Memorandum

Subject: SUB-20-01 – 6-Lot Subdivision at 4096 Cornwall Street

Subject: Public Testimony for West Linn Planning Commission Public Meeting
SUB-17-04

Willow Ridge
Site Plan

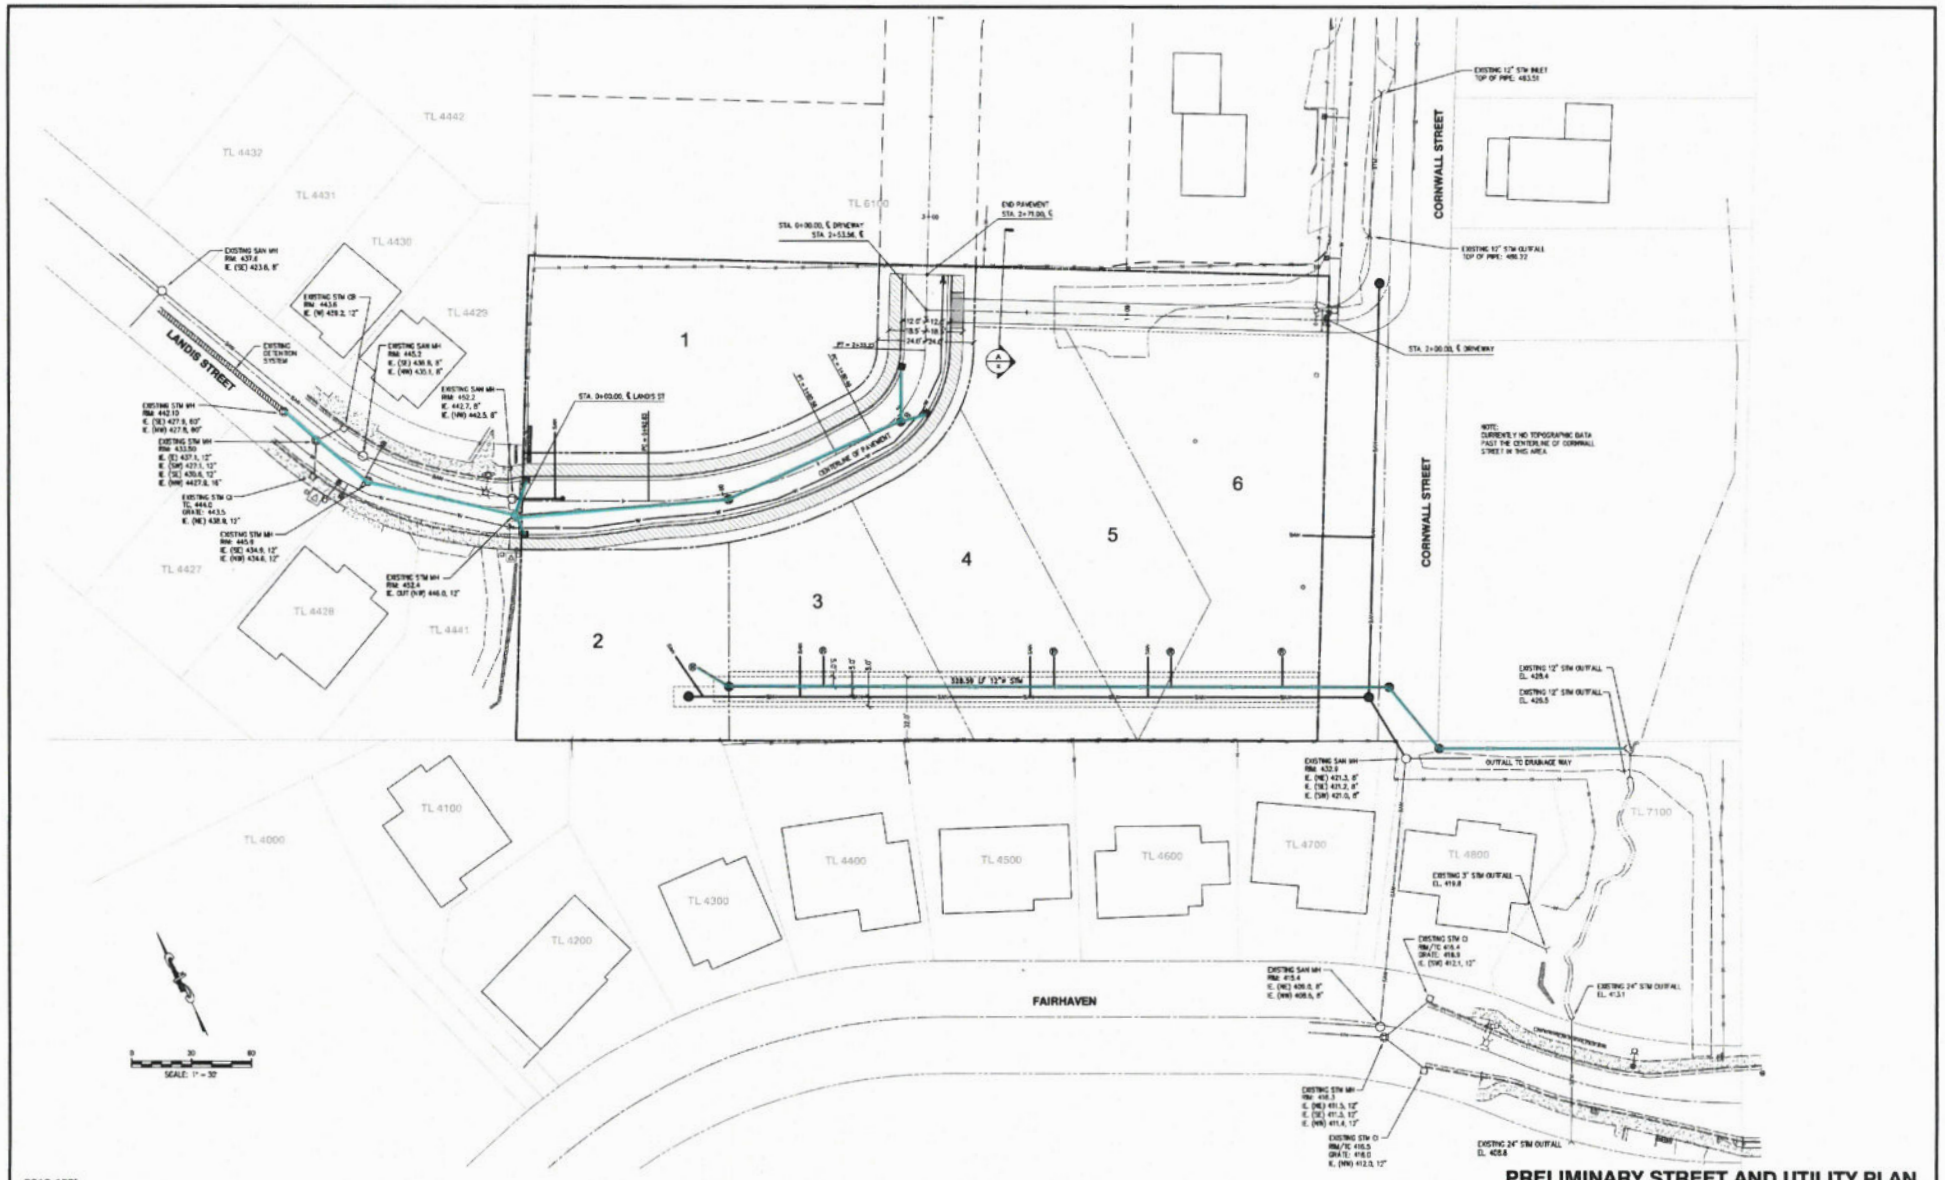
- The prior plan reflected a road connection through our project that connected Landis Street to Cornwall Street. Many objections were raised during the planning commission meeting with concerns of cut-through traffic, safety, and the poor current condition of Cornwall street that many stated couldn't support more traffic. We addressed this by NOT connecting Landis to Cornwall. Aside from a gated connection at the north corner of our site (for emergency vehicles only, and code required), our new design reflects no connectivity through our project.

- The prior plan had a storm pond placed off-site, on the city's property (tax lot 7100), fronting Fairhaven Way. Many objections were raised during the planning commission meeting with concerns of what the finished pond would look like, and converting a natural landscaped area into a detention pond. We addressed this by NOT placing a pond on this property. Storm is now addressed underground. The street on our project will capture all of it's run-off via catch basins that are hard piped into an existing sub-grade storm system in Landis to the west of our site. This system was oversized during the prior development to accommodate for future development and supports this connection. In addition, all impervious roof and driveway areas, affiliated with the 6 future homesites, will be collected and hard piped into individual rain gardens on site (water quality), with all overflow that is hard piped and conveyed to the existing creek south of Cornwall St. This will have no adverse impact to the park's tax lot 7100. The current aesthetics of it, as seen today, will remain unchanged.

improvements are in place (post development), the majority of the hillside water will be captured and carried off to appropriate discharge points. Our neighbors to the south will see a decrease in saturated yards once this development is constructed and per these plans.

- There were concerns voiced about tree removal and impacts to land disturbances and/or added impacts to the water run-off. Per our plans, we are not removing any trees documented as significant by the city arborist. We are preserving trees on lot 1 (large cluster to the west), lot 2 (large cluster to the west), and trees along the southern property line. We like trees too, and are only removing those directly within the construction zones of the roadway and homesites. We will be replanting many new trees on site (as required by city mitigation code) and will be conscientious about planting them in areas to assist in providing continued privacy to both our exiting neighbors and future home owners. The removal of all trees will be mitigated for and replanted.

Willow Ridge
Tentative Plan

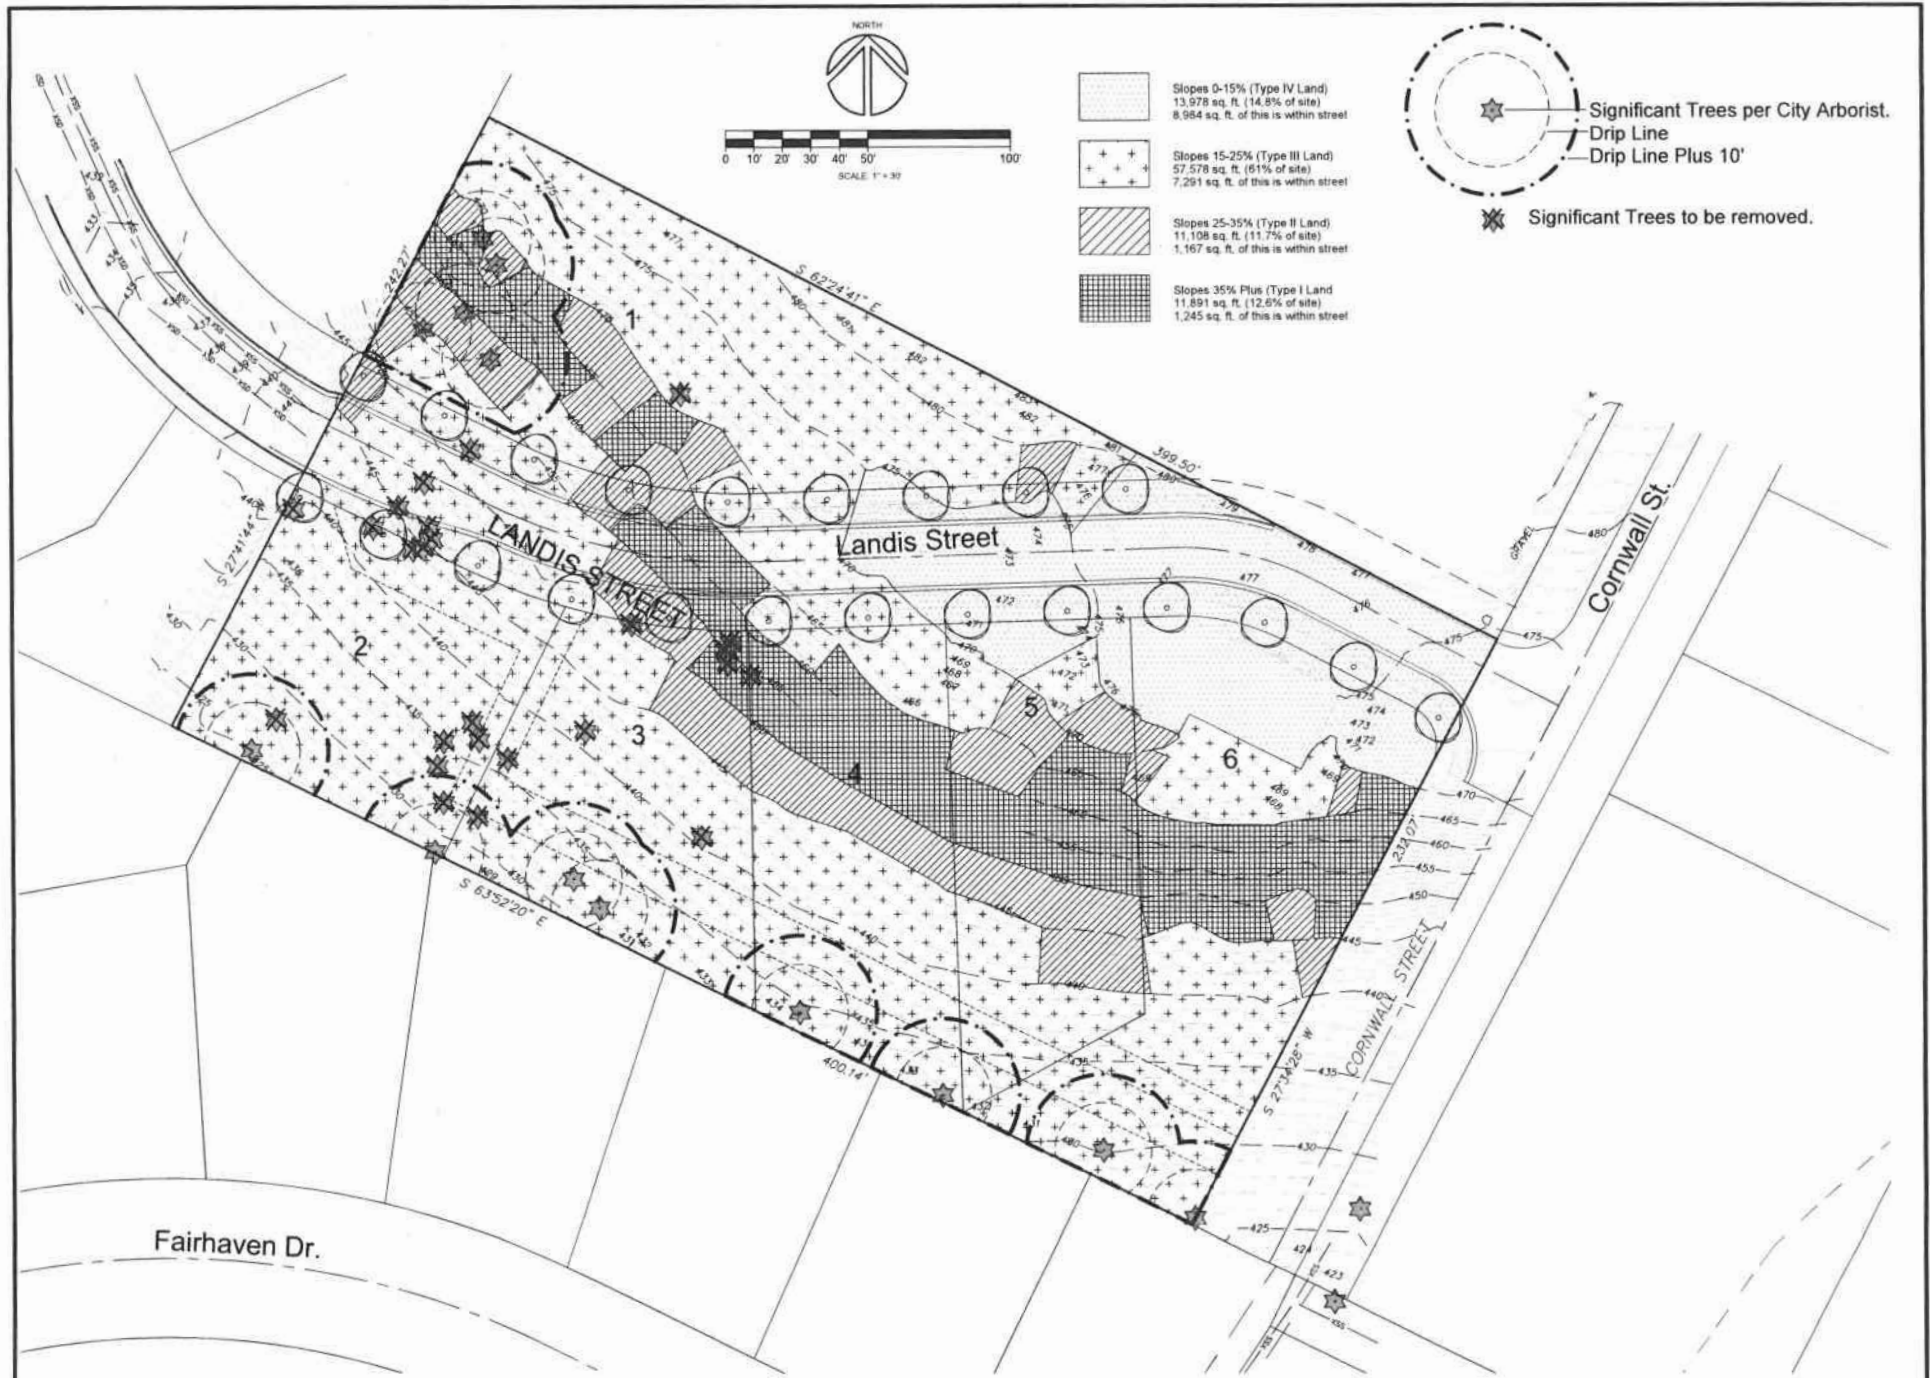
- As you know, there has been much concern by the neighborhood regarding wanting to avoid cut-through traffic from Landis Street to Cornwall Street due to the poor condition of Cornwall Street. This is the reason why the Tentative Plan shows an emergency vehicle gate at the point of connection of the 12' paved drive with Cornwall Street. It is our understanding that Public Works has taken the position that CDC 48.030I precludes having a gate on a public alley. We disagree with this interpretation as that section specifically prohibits "gated accessways" to residential subdivisions. An alley is not an accessway in the context of this section. Access to the subdivision is provided via Landis Street, not the alley.

- Should the Planning Commission determine that the Public Works interpretation of CDC 48.030I is correct, in order to continue with our objective of satisfying neighborhood concerns about cut-through traffic from Landis to Cornwall Street, our response would be to revise Condition 7 as follows:

- As a point of clarification, the staff version of Condition 7 incorrectly notes that there is a 25 foot strip north of the alley. The 25' dimension shown on the Tentative Plan is for the full width of what is identified as an alleyway, including the paved driveway. We apologize that the drawing is unclear with respect to the dimension.

A. LOT 6 CONCERNS: THE EMERGENCY ROAD/ALLEYWAY

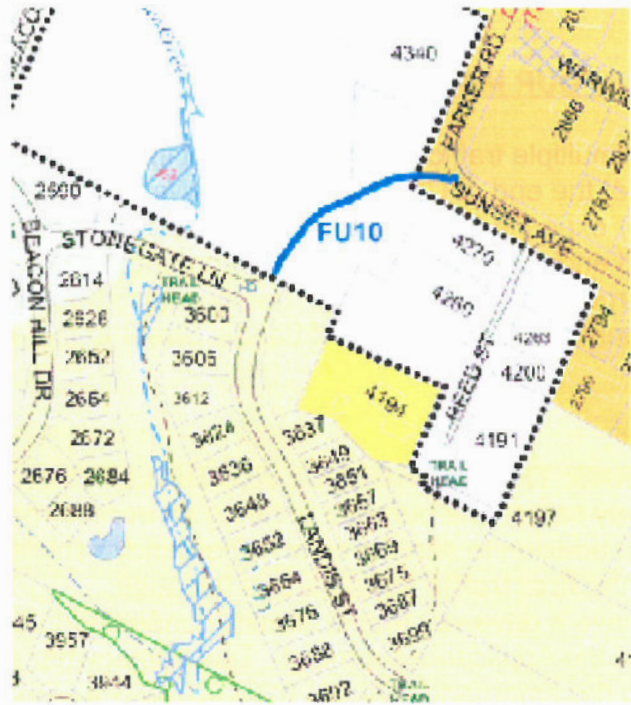
This new alleyway serves the purpose of being an access road to Willow Ridge's lot 6 driveway, in addition to serving as an emergency vehicle road. This arrangement is the **first traffic safety issue** because:

- 1) Lot 6 does *not* have a driveway that is directly connected to Landis Street, but this was not stated in the Applicants submittal. This homeowner must access his property utilizing the emergency vehicle road/alleyway just to get to his driveway.
